### **KIRKLAND ROAD, ENNERDALE BRIDGE – APPLICATION FOR 11 DWELLINGS**

**CONSULTATION WITH PLANNING AUTHORITIES  
ROAD NO C4004  
FULL PLANNING PERMISSION 11 DWELLINGS, LAND ADJ TO KIRKLAND ROAD, ENNERDALE**

Drawing Title:  
**PROPOSED FOOTWAY  
 OVER CROASDALE BRIDGE**

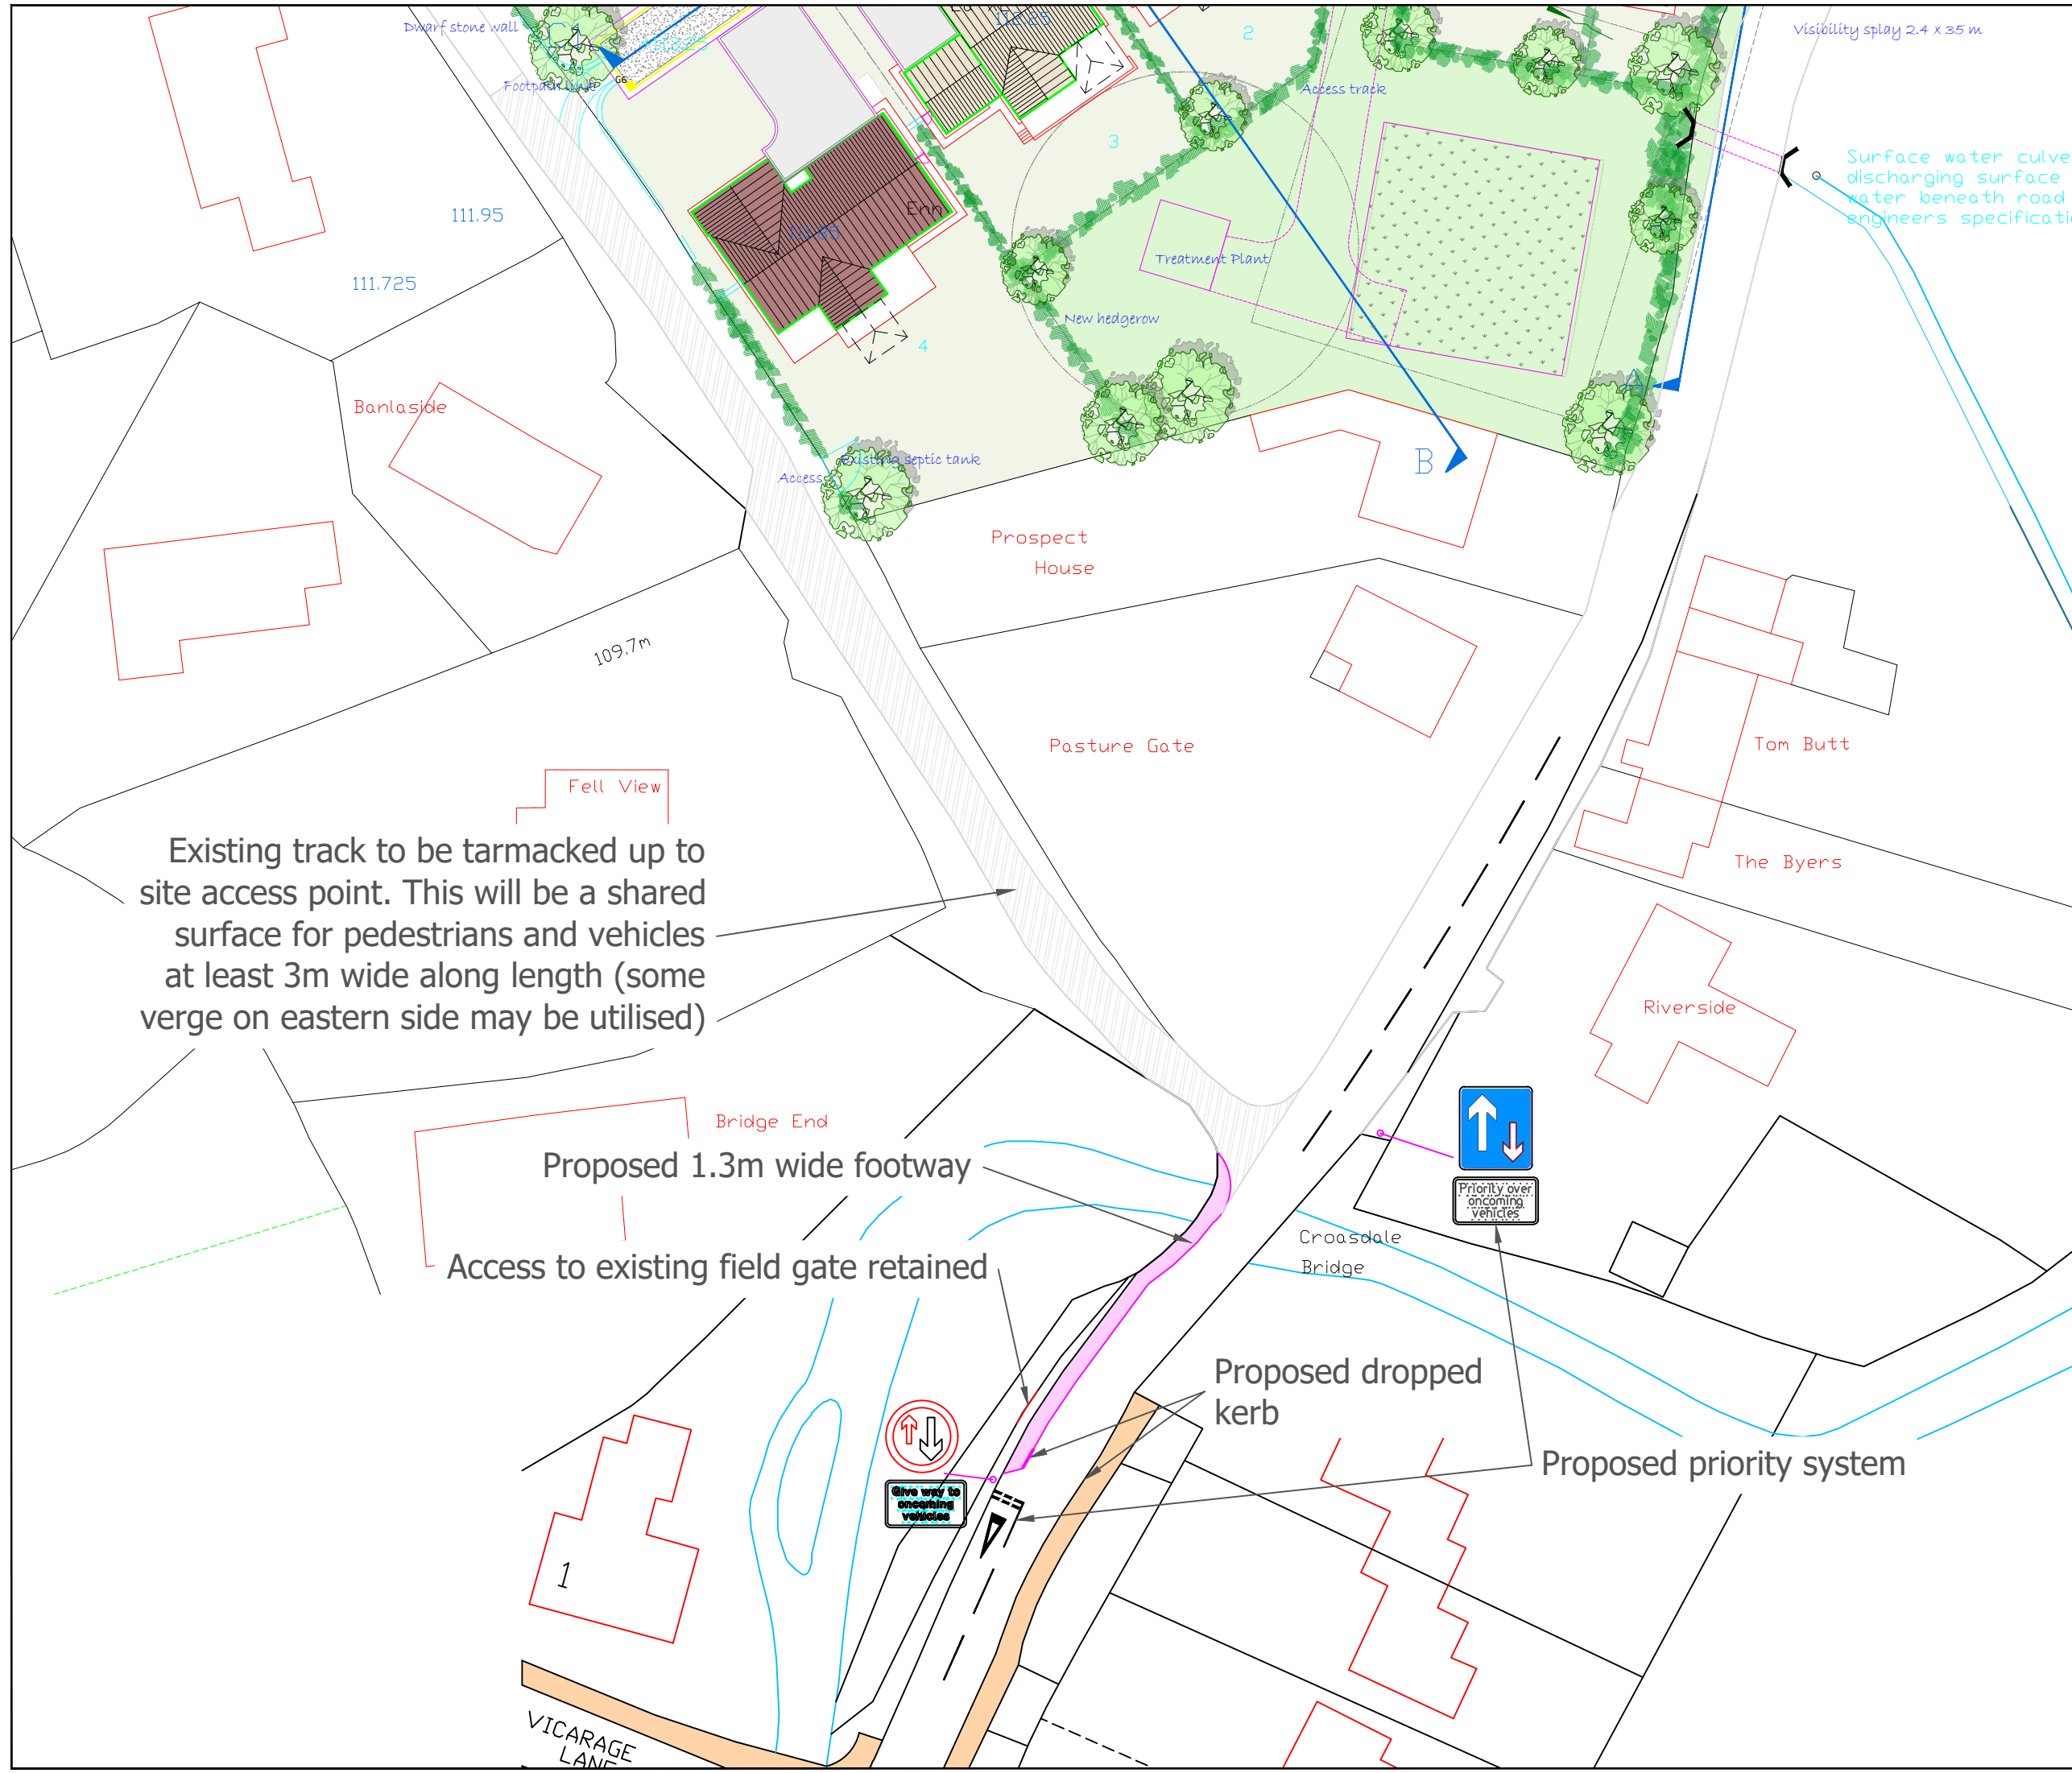
Thank you for the correspondence relating to previous Highway Authority comments, it is noted that a footway has been proposed over Butt Bridge C4004/1496 (Croasdale) as this is an alteration to the existing highway layout, consideration must be given to the height of the Parapet and Approach Walls, there will be a requirement to alter the height where applicable to raise these up to a standard of 1.00m above the footway and along the length of the proposed footway in line with DMRB TD19/06 standards to contain errant vehicles and protect pedestrians.

Consideration must be given to visibility splays affected by alterations to the walls.

Given the above it may be worth considering siting the footway on the opposite side of the carriageway than proposed in Drawing No 1722-PL202, this may improve the visibility out of the private lane and enable large vehicles to turn in and manoeuvre easier than what is currently proposed, again the Approach Wall and Parapet may need altered to suit but this would possibly be over a smaller portion of the bridge.

In either case a plan showing that large vehicles are able to access and egress the private lane should be shown as the lane at its narrowest point just off the adoptable highway is 3.00m wide, Drawing No 1722-PL202 shows a proposed 1.8m footpath along the length of the lane towards the development, at its narrowest point is it proposed that vehicles will over run this footway when entering or leaving the lane? Also considering the gradient will this footpath be DDA compliant?

From which side of the bridge is it proposed to give priority?

Due to the nature of the carriageway being narrow towards Butt Cottages it may be more suitable to give priority to the North rather than the South to prevent vehicles stacking at the narrowest point, this should be clarified.

WYG Drawing A103748/C002A, attached, shows the proposed changes to the road layout.

The proposed footway is 1.3m wide and similar to the existing footway over Ehen Bridge near the school. The proposed alterations at Croasdale bridge would leave a carriageway 4.3m wide at its narrowest point and a priority system for vehicles is proposed. Priority is given to southbound traffic to avoid vehicles stacking at the narrower section near Butt Cottages. Appropriate signage and road markings are provided. Access to the existing field gate is retained. Dropped kerbs are provided and pedestrians will cross the carriageway onto a clear section of the existing footway.

It is proposed that the back lane be tarmacked up to the site access point, effectively creating a shared surface for pedestrians and vehicles. Vehicles currently accessing the lane will do so in the

same manner as the existing arrangement, however there will be an improvement in the width for all users and an improvement in the surface for all users. Visibility on egress is improved by the addition of the footway over Croasdale Bridge.

Existing track to be tarmacked up to site access point. This will be a shared surface for pedestrians and vehicles at least 3m wide along length (some verge on eastern side may be utilised)

Proposed 1.3m wide footway  
 Access to existing field gate retained

Proposed dropped kerb  
 Proposed priority system

A	FOOTWAY LENGTHENED AND NARROWED	EB	NB	NB	17.10.19
REV	DESCRIPTION	BY	CHK	APP	DATE
